W-1 LEON CREEK: HWY 151 TO HWY 90 - UPPER SEGMENT
Solicitation Number: CO-00351
Job No.: 19-4528

ADDENDUM 2
September 24, 2020

SAWS JOB NO. 19-4528
W-1 LEON CREEK: HWY 151 TO HWY 90
UPPER SEGMENT
LINE "A" PLAN AND PROFILE
STA 54+00 TO STA 58+00

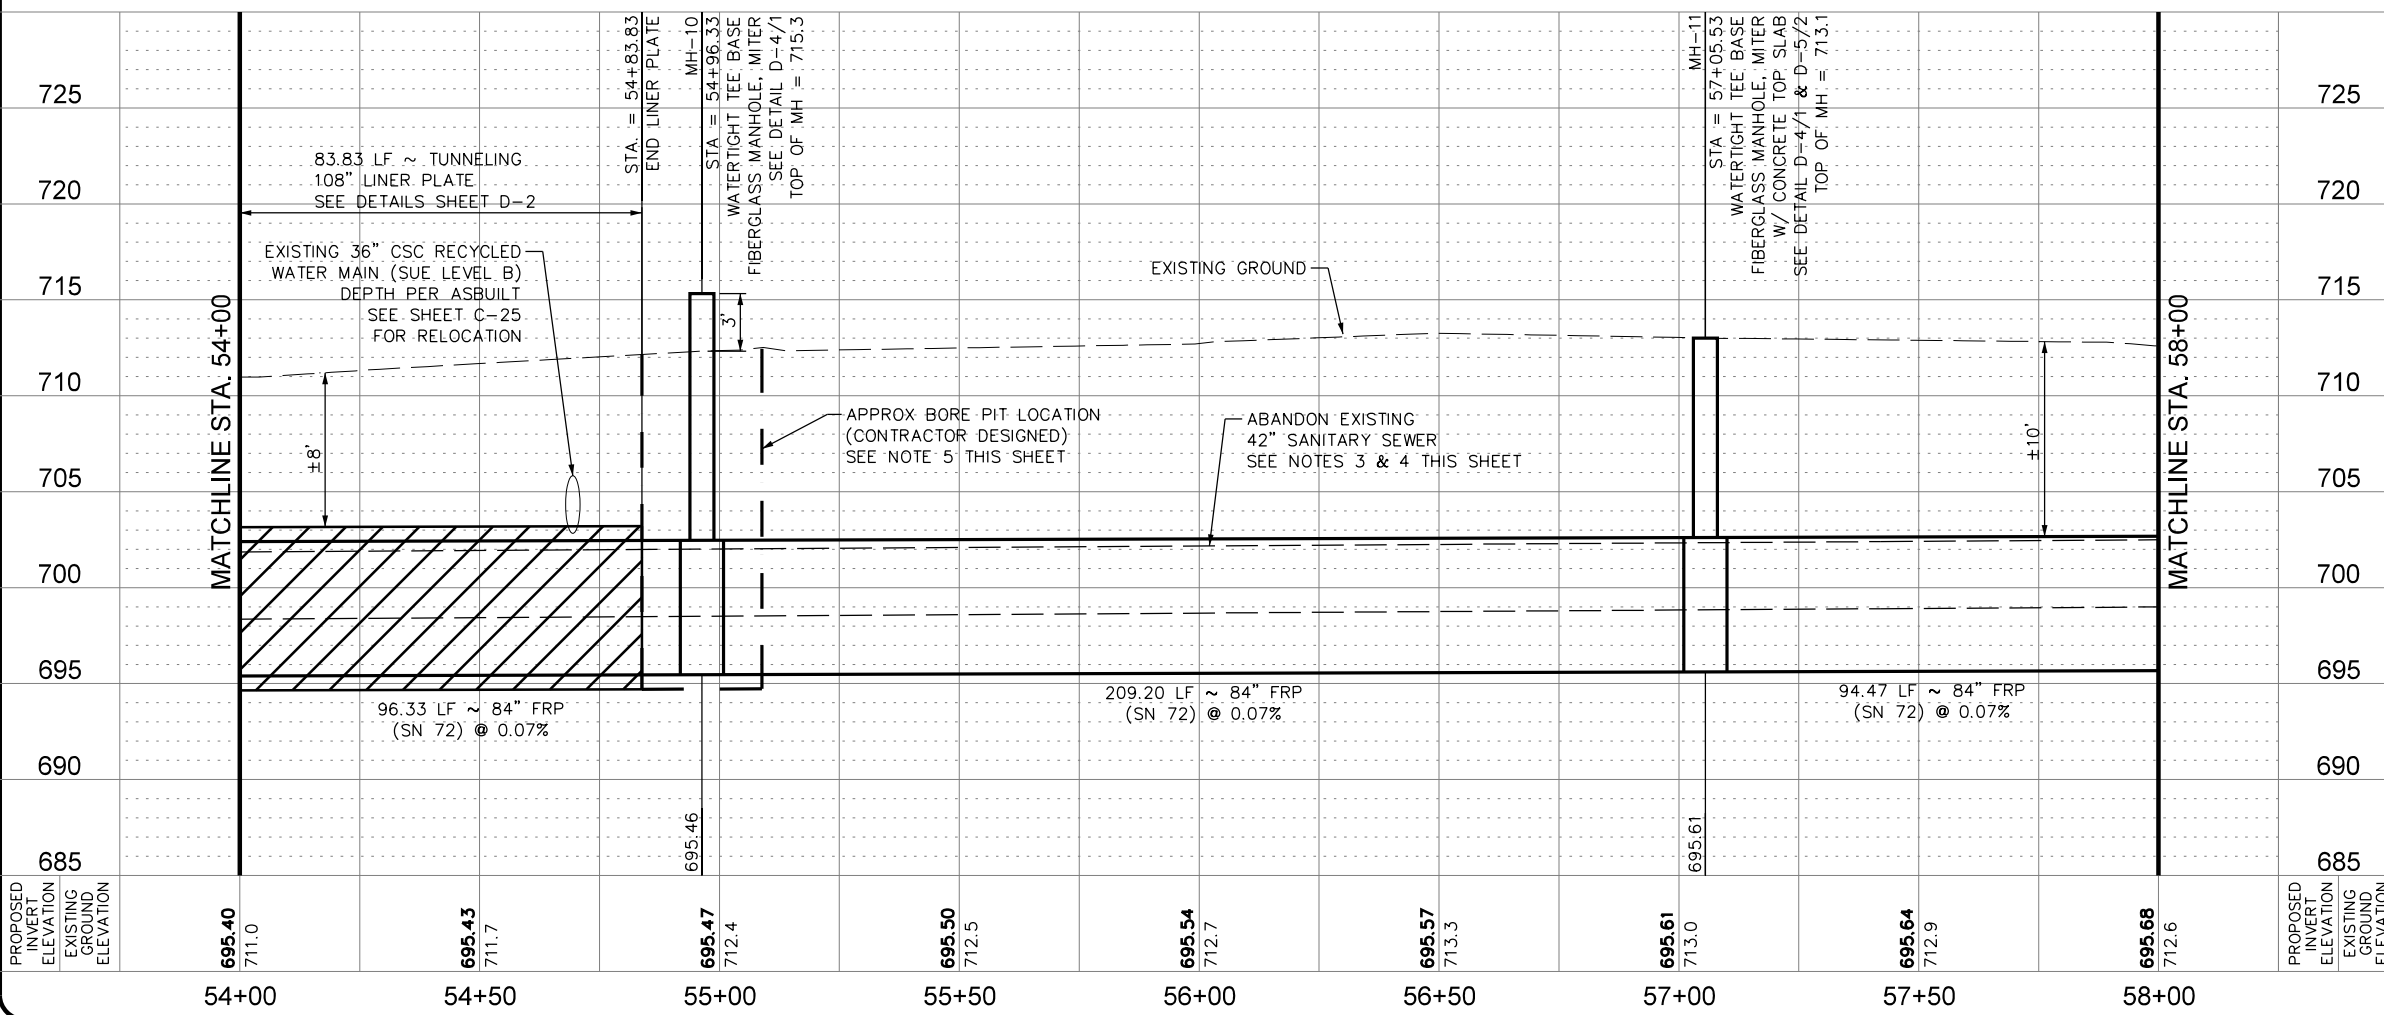
Q4: On Sheet C-12 the existing recycled water line is labeled as 30" RW in plan view and 36" in profile. Please clarify.

- Revised in plan view the pipe size of the CSC Recycled Water Main to 36”RCW
- Sheet C-21: Line “E” Plan and Profile Sheet STA 1+00 to 1+42.80 – Replace sheet in its entirety.

Response: *The line work for the RW line in plan view will be revised to indicated 36" RW.*

Sheet **C-21**
 44 of 67

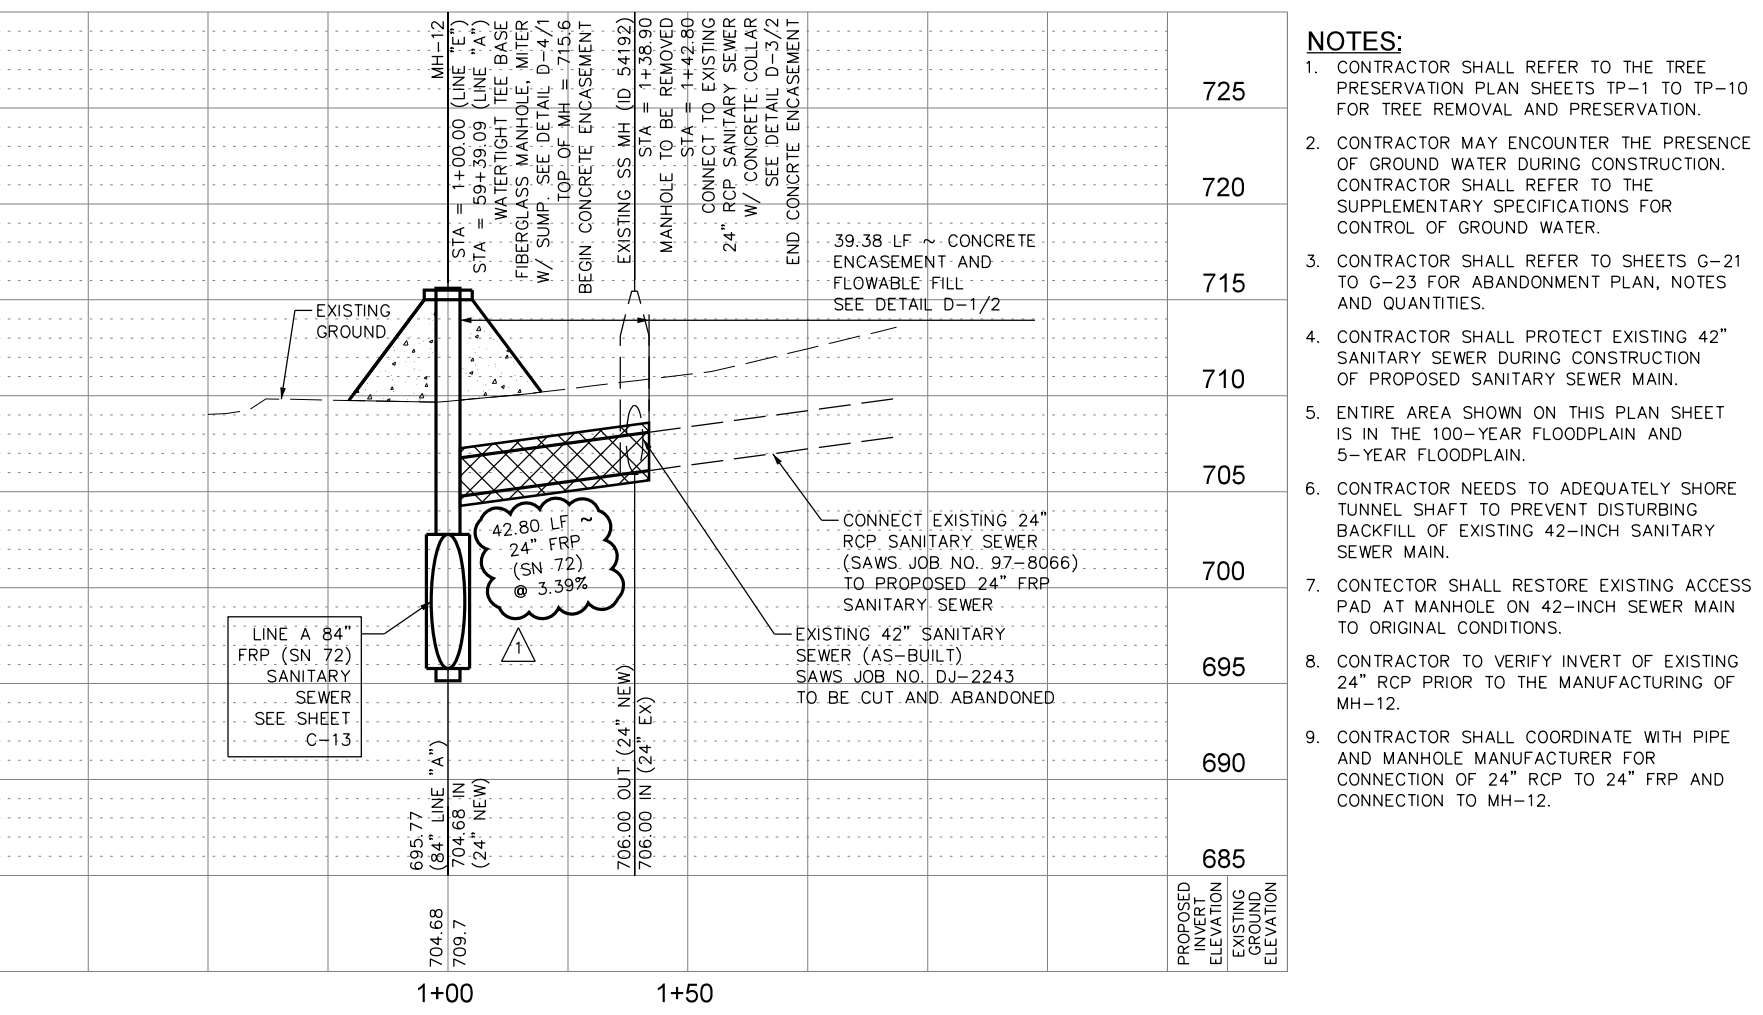
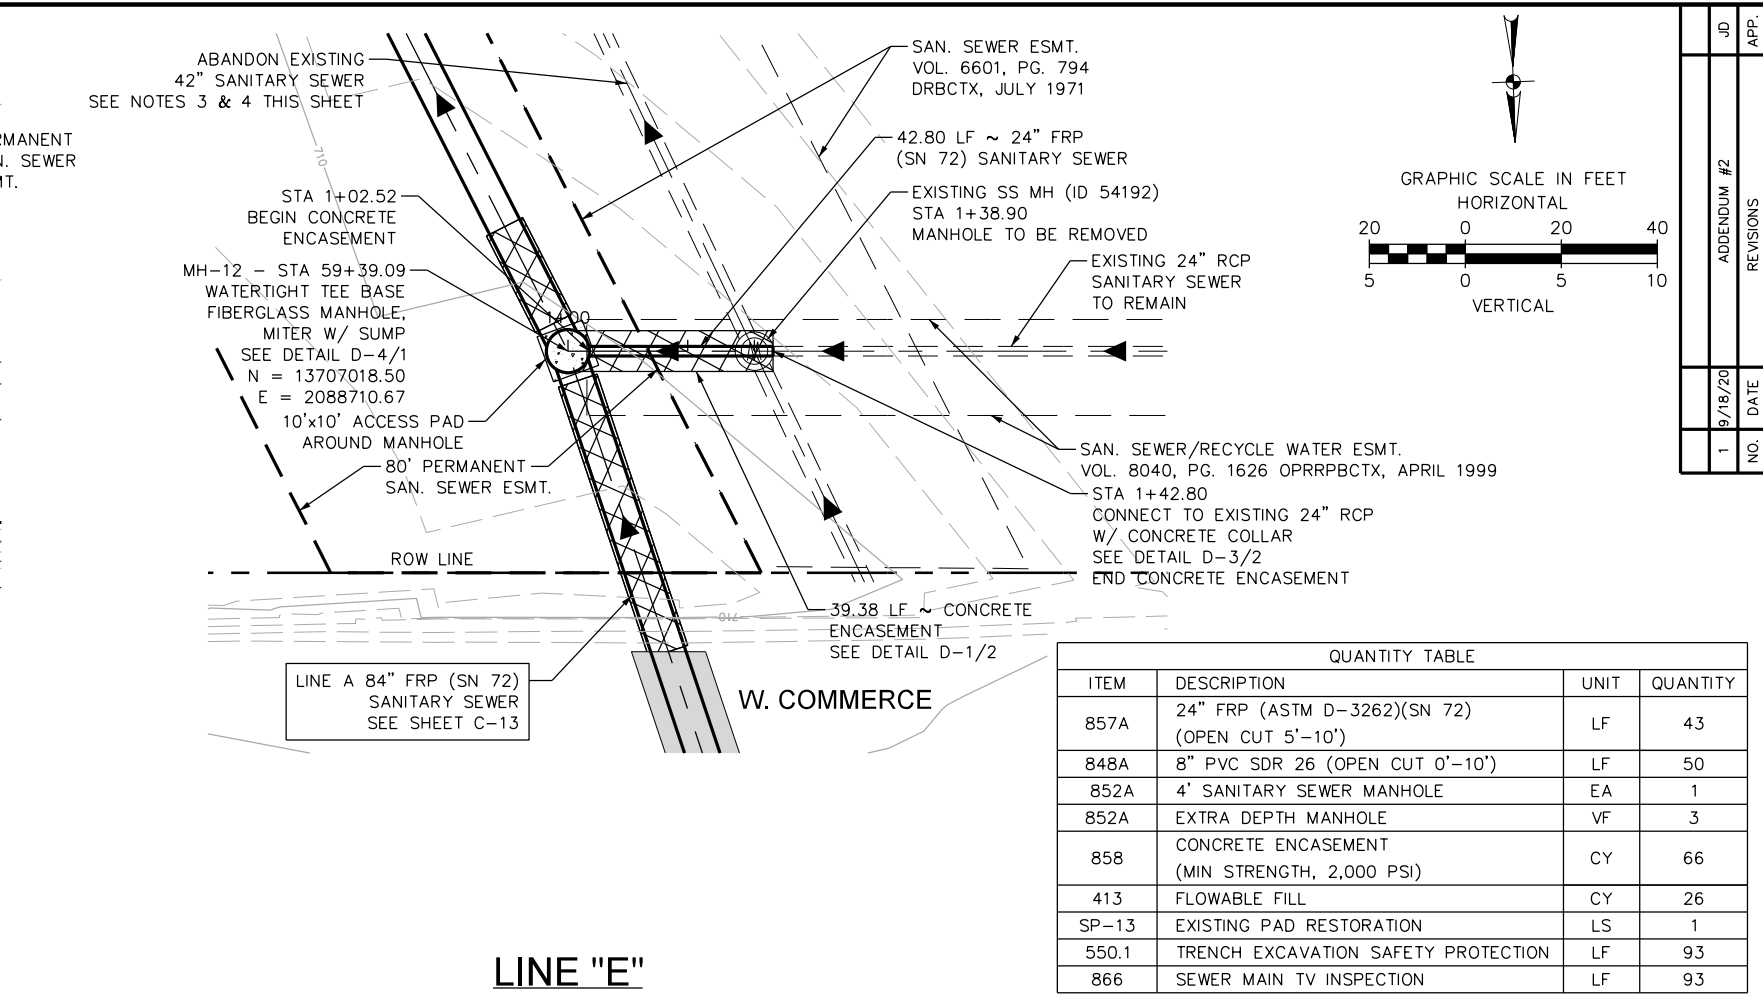
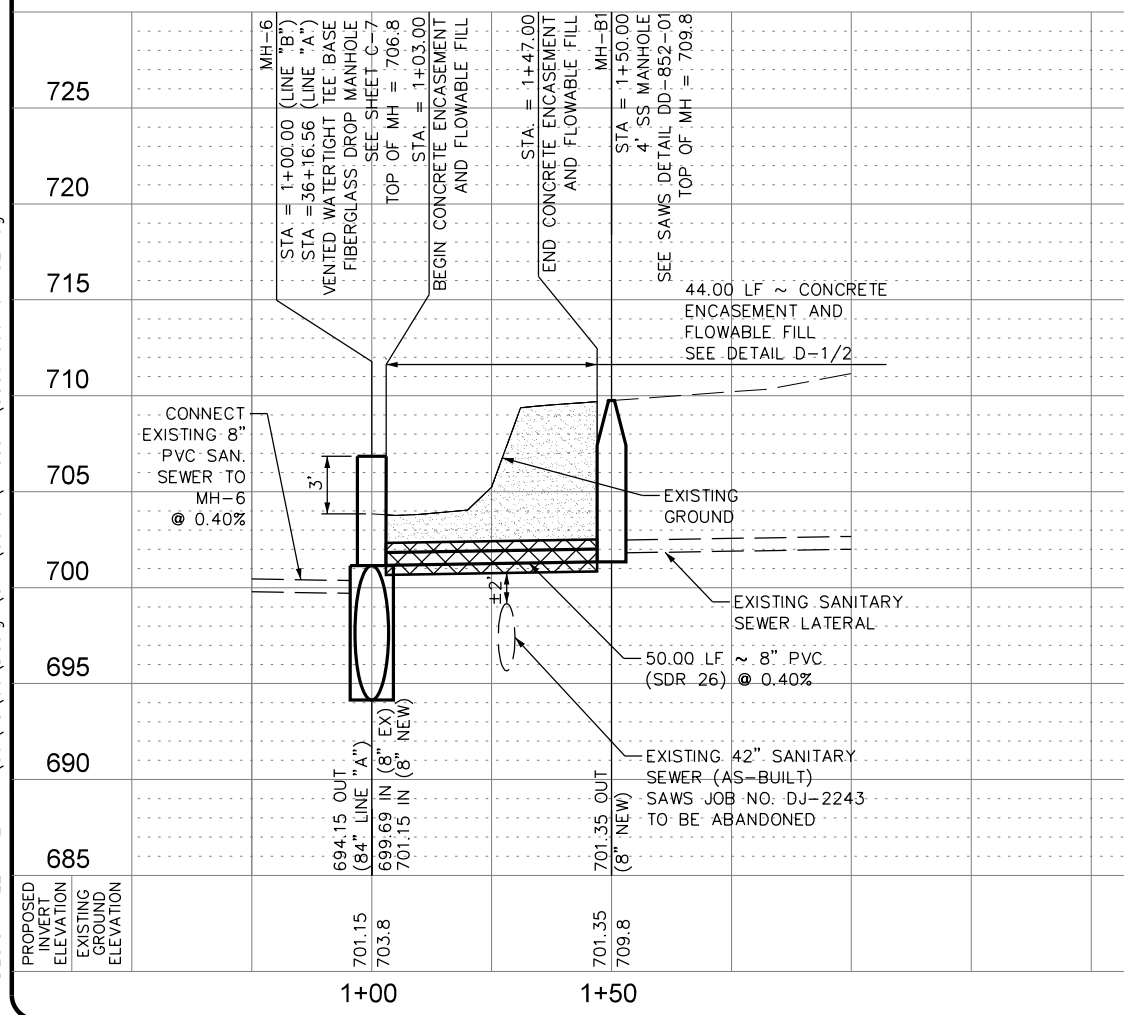
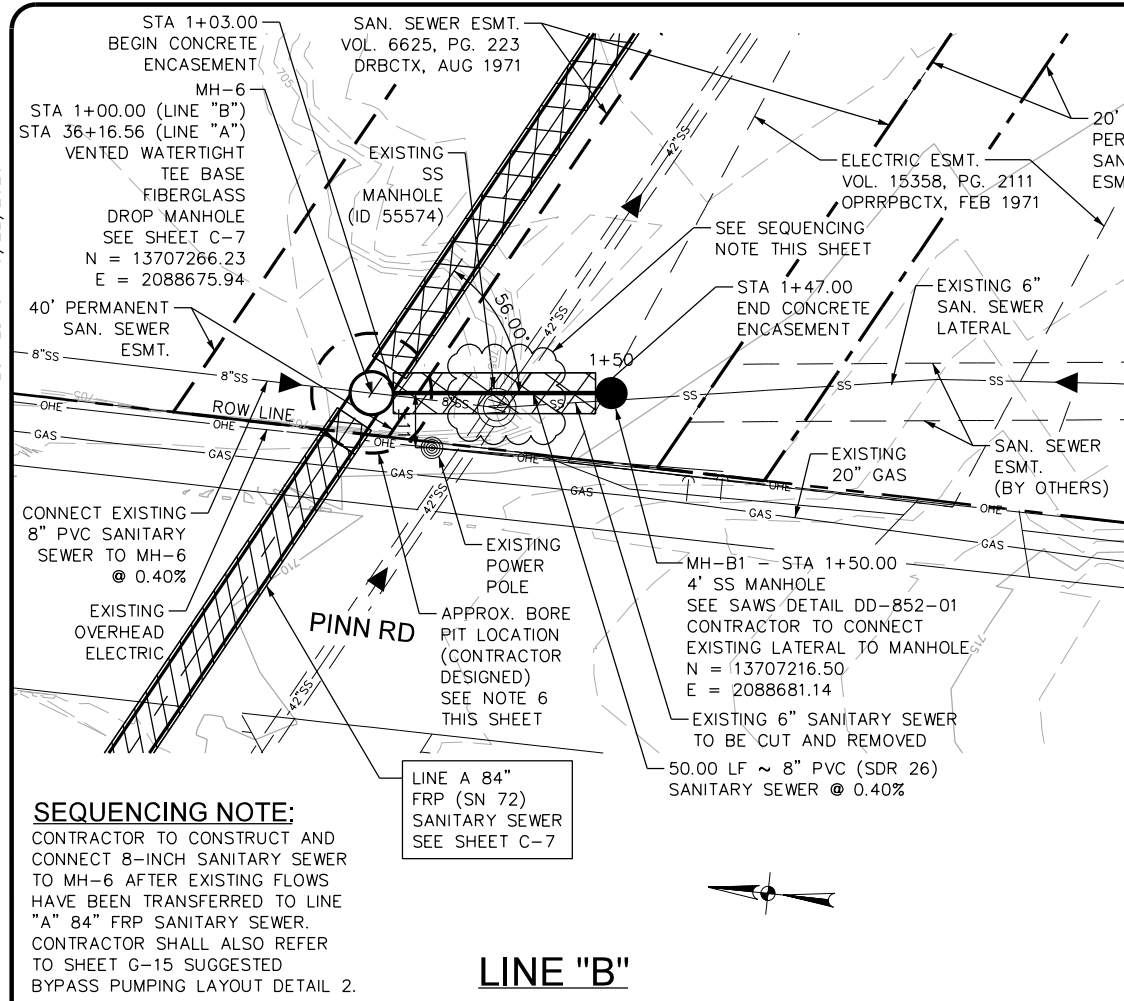
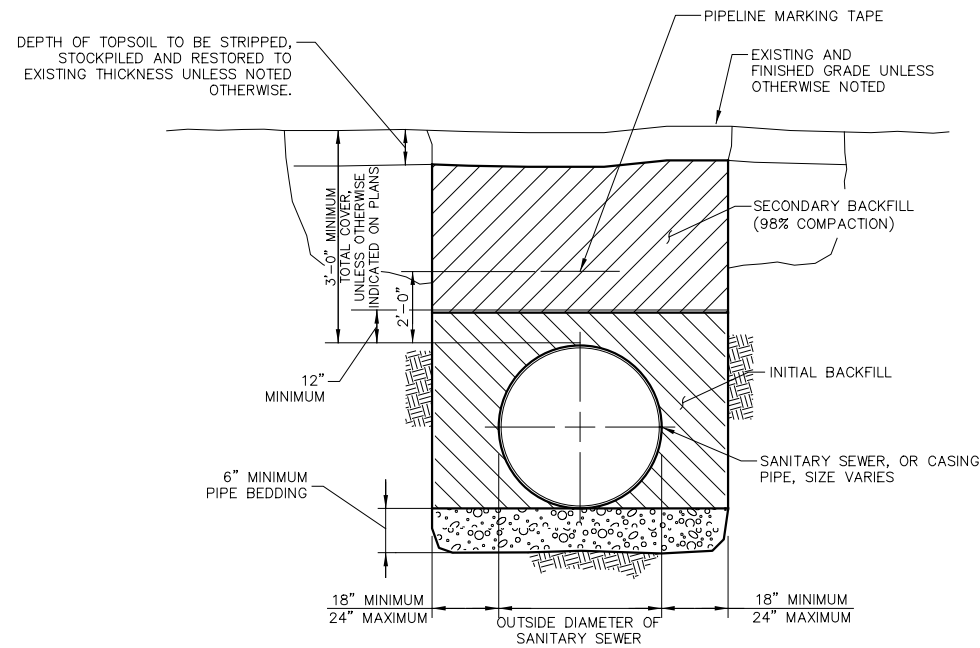
Q3: Line E is called out as 8" PVC in profile view on sheet C-21. Please clarify.

- Relabeled Profile to indicate 42.80 LF, 24” FRP (SN 72) @ 3.39%
- Sheet D-1: Typical Trench Details
 - , Revised Minimum and Maximum Asphalt Pay Limits

Response: *Line E will be revised in the profile view to indicate 42.80 LF and 24" FRP (SN 72).*

3 TYPICAL PIPE TRENCH (ASPHALT SURFACE)
FOR 84" FRP PIPE
N.T.S.

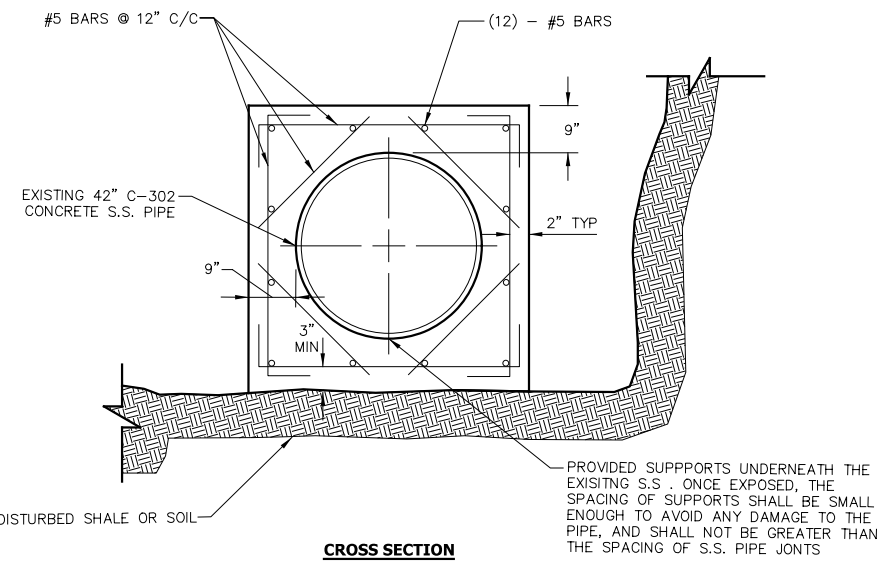
Q1: The typical pipe trench detail 3/D-1 indicates a 14' minimum and 14' max pay width for trench repair. Based on the size of pipe being installed on this project the minimum and max are not possible (7' for pipe, 1' minimum either side, 2' asphalt type B either side and 2' more for asphalt type D or C – $2+2+1+7+1+2+2 = 17$; would be 18 feet if 18" either side of the pipe). Please clarify if contractor's are required to carry additional width of paving above 15' as incidental cost to the pipe installation.

- o Added note to Detail 3 for Pinn Road Access Road

Response: *The asphalt pay limits will be revised to 17'-0" MIN/18'-0" Max on Sheet D-1, detail 3.*

⊙⊙⊙ PINN ROAD ACCESS ROAD
STA. 10+00 TO STA. 36+26
TY B (10" MIN)
TY D (2" MIN) WITH 20' MAX ASPHALT PAY LIMITS
